CONSTRUCTION SUMMARY

Summer Ridge Estates Inc.

LOT NUMBER	PHASE	HOUSE TYPE	CLOSING DATE
005 BLOCK 289	1	DESERT ROSE (25-01-A2) ELEV A2	20-Nov-25

Invoice Number: 8776

UPPER LEVEL
ELEV.A2

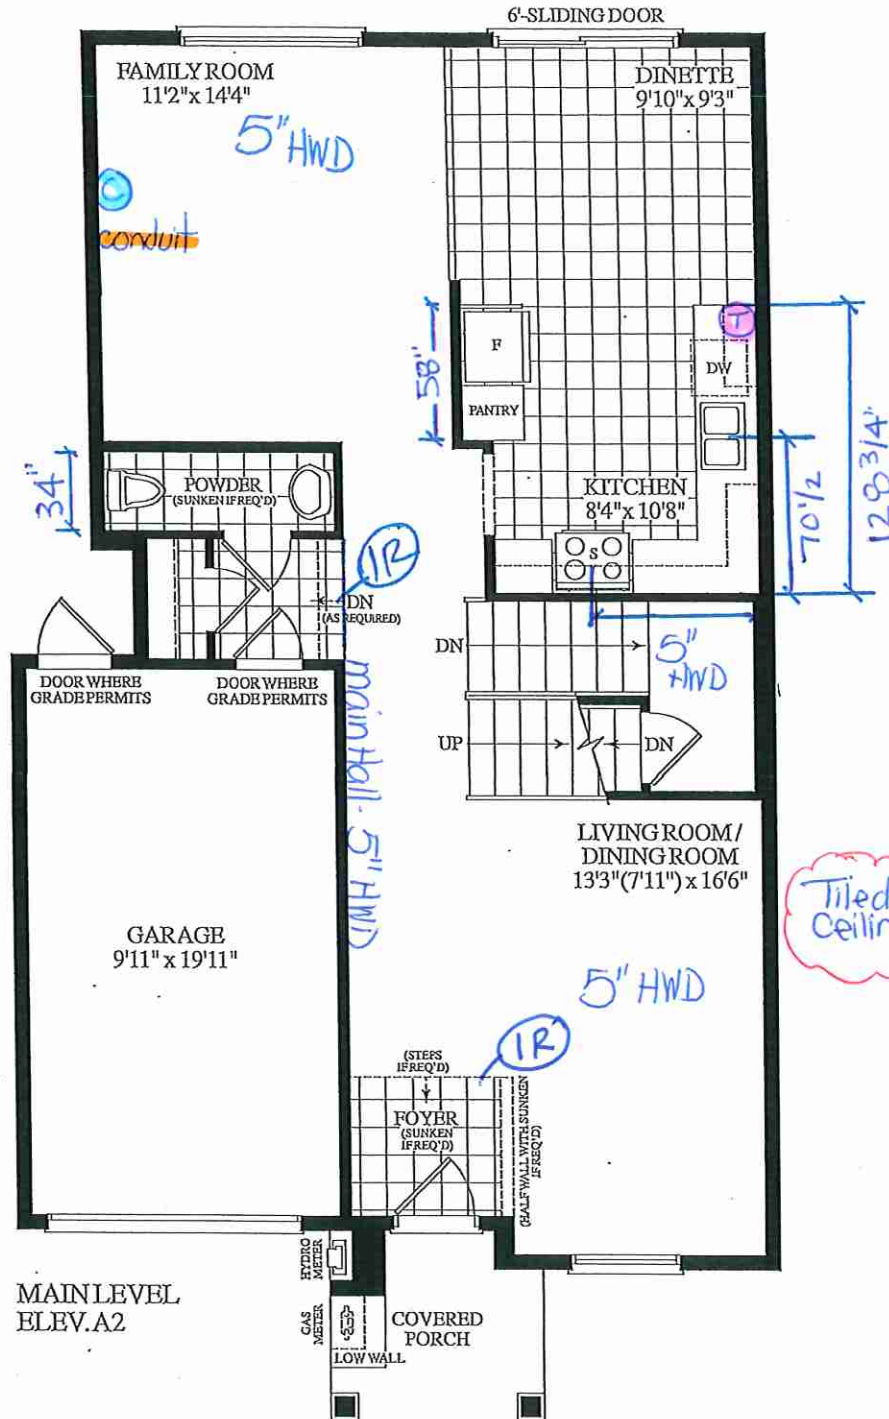
1 - Install Standard Cable Rough-Ins (x2) and Install Standard Telephone Rough-Ins (x2) (See Sketch)

1 - MAIN FLOOR & 2ND FLOOR - INTERIOR DOORS - Install UPGRADE Interior Door Style - LINCOLN PARK, SMOOTH (Standard Height) - To be installed throughout main floor and 2nd floor, where applicable (See Sketch)

1 - MAIN FLOOR & UPPER HALL - FLOORING - HARDWOOD - Install prefinished 5" x 3/4" VINTAGE WHITE OAK BAROQUE (Character Pearl) in lieu of builders standard prefinished 3 1/4" x 3/4" Vintage Red Oak Natural Hardwood.

Note: To be installed throughout main floor and upper hall, where applicable. To Include; LivingRoom/DiningRoom, Main Hall, Family Room, Upper Hall and Applicable Landings (See Sketch)

1 - STAIRCASE - Stain Oak Staircase from Main Floor to Second Floor, where applicable. To be Stained - Vintage Red Oak BAROQUE - To Include; Treads, Risers, Handrail and Post, where applicable (See Sketch)

EDGE
DETAILS

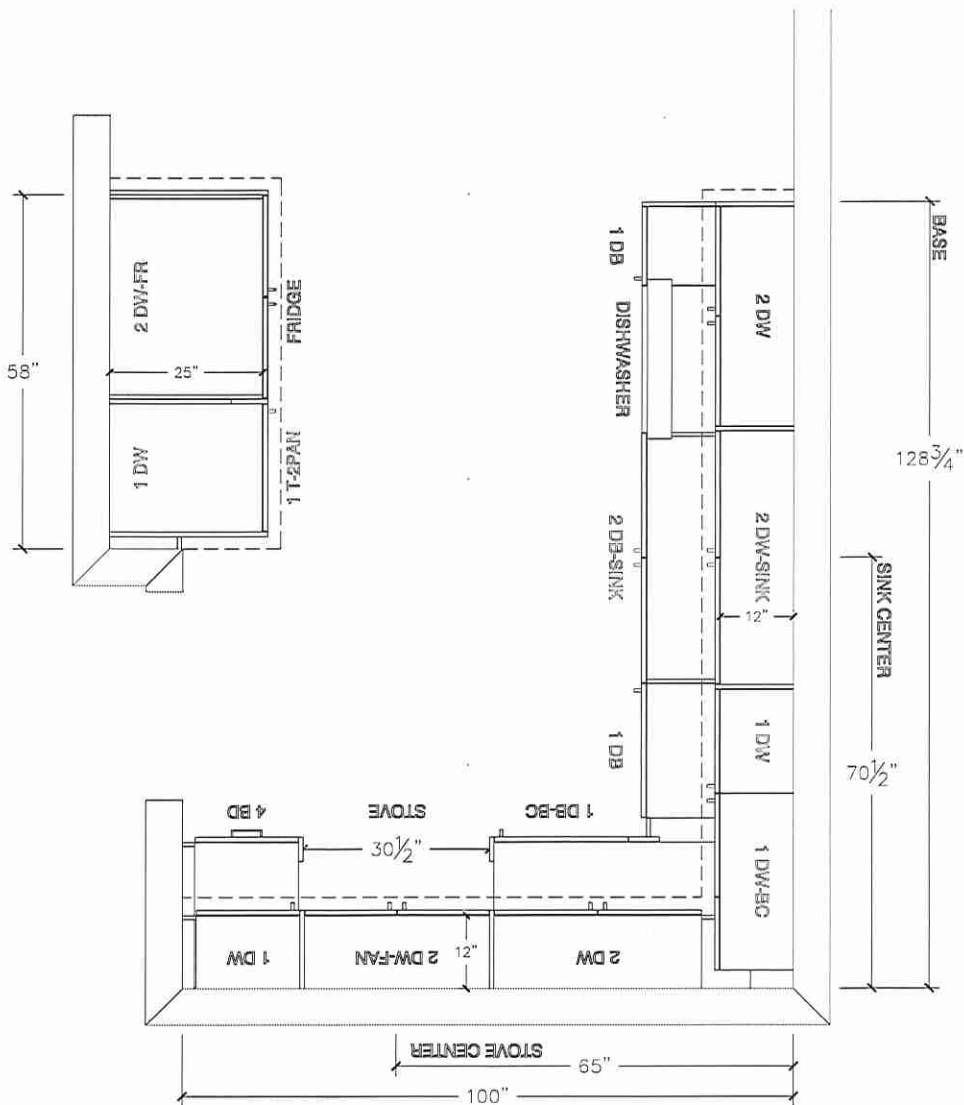
1 - KITCHEN - COUNTERTOP EDGE - Install UPGRADE " L " EDGE PROFILE - To be installed throughout kitchen countertop, where applicable (See Sketch)

KITCHEN PLAN

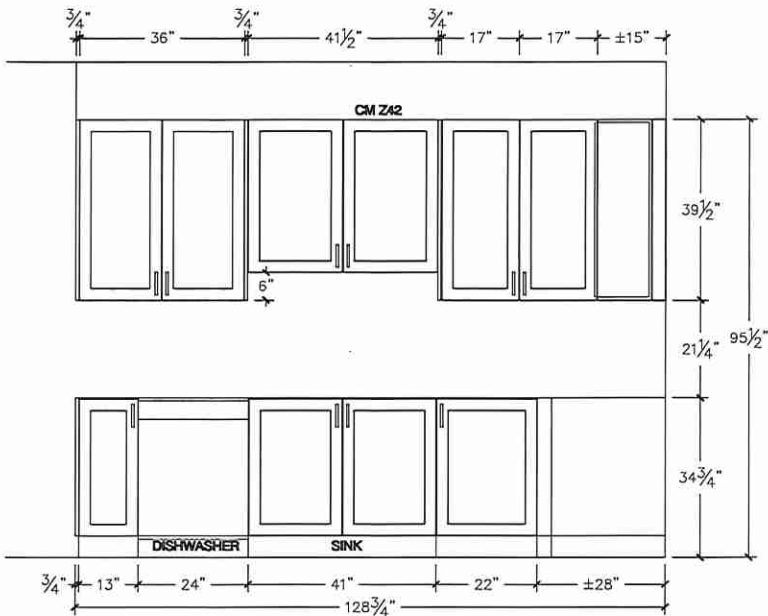
1 - KITCHEN & BATHROOMS - Purchaser has DECLINED All Upgrades offered during decor appointment at the decor centre for kitchen & bathroom cabinetry. Standard Kitchen Layout & Standard Bathroom Vanities to be installed as per standard plan. (See Sketch)

1 - KITCHEN - COUNTERTOP - Install UPGRADE #2 Stone Countertop – EVEREST WHITE SHIMMER - To be installed throughout kitchen, where applicable (does not include stone backsplash) (See Sketch)
